NORTHEASTERN CONNECTICUT COUNCIL OF GOVERNMENTS
ENGINEERING PLAN, DRAINAGE REPORT AND WETLANDS REPORT REVIEW
PERTAINING TO
PROPOSED WILLOW HILL EVENTS WEDDING/EVENT VENUE
(ASSESSOR'S MAP 19, BLOCK 18 - LOTS 18A & 18B)
WOLF DEN ROAD
BROOKLYN, CT
(March 17, 2023)

The comments contained herein pertain to my further review of a revised set of plans entitled "Special Permit Application for Wedding/Event Venue for Willow Hill LLC, 459 Wolf Den Road, Brooklyn, Connecticut, Dated: November 30, 2022, Revised: March 8, 2023," prepared by J&D Civil Engineers, LLC and from observations made during a site visit by myself on March 14, 2023.

From: Daniel Blanchette <daniel@jdcivilengineers.com>
Sent: Tuesday, March 21, 2023 2:34 PM
To: Jana Roberson; Syl Pauley
Cc: Gregory Fisher
Subject: Revised Plans for 459 Wolf Den Road
Attachments: 22172 Wineland - Site Plans 2023-03-21.pdf

The following is an itemized response to Syl's second review letter:

NOTES

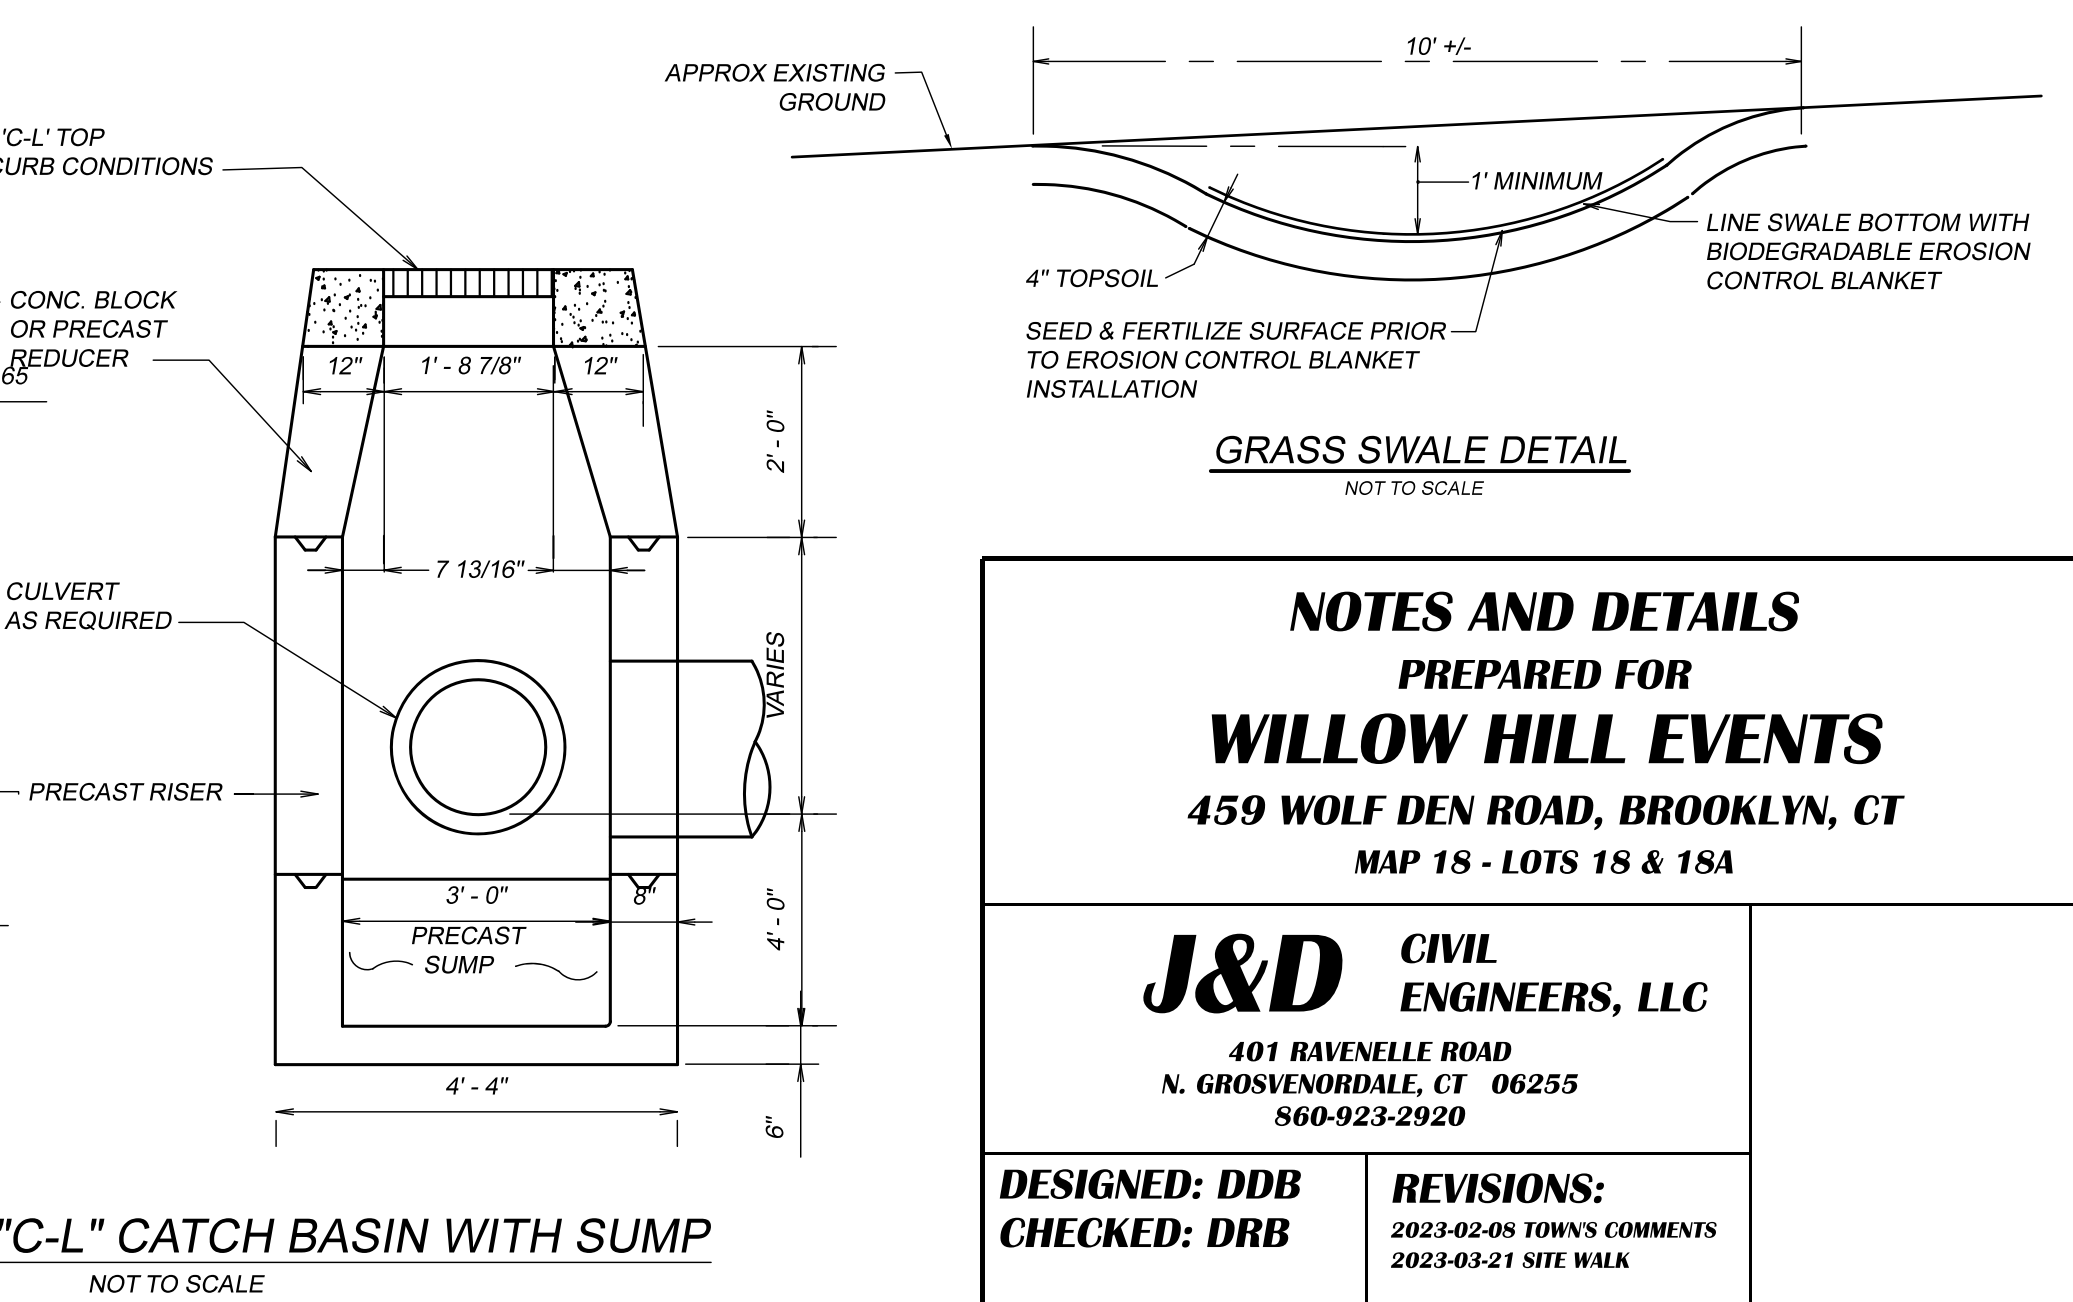
1. The existing driveway to be altered and the proposed driveway are "commercial" driveways, not residential driveways. The "Residential Driveway Section Detail" appearing on Sheet 6 of 6 is not applicable and, furthermore, can be found in the Brooklyn Public Improvement Specifications only for showing construction of a driveway apron. The detail needs to be removed and one showing a driveway cross-section with materials and dimensions that will handle heavy vehicles (buses, fire trucks, delivery trucks, etc.) be added to the sheet in its place and labeled as a "commercial driveway." A commercial apron detail is also required.

5. The "Drainage Pipe Installation Detail" on Sheet 6 of 6 indicates that solid pipe shall have a 6' (feet) cover of crushed stone. This symbol needs to be changed to 6" (inches). Also, the crushed stone needs to be noted as "washed" crushed stone so that fine mineral particles are minimized within the stone matrix.

1. The previous detail for "residential driveway" has been removed from Sheet 6. A cross section for the paved driveway has been added to Sheet 6. Additionally, several dimensions were added to the driveway on Sheet 4. Together, they should contain all the necessary information for construction, such as the example you provided from the Town of Franklin.

5. The detail for drainage pipe installation has been revised.
6. The existing driveway under the deck is shown more clearly.
7. The applicants preference is for pea stone, and they are aware it will require more maintenance than typical processed gravel.
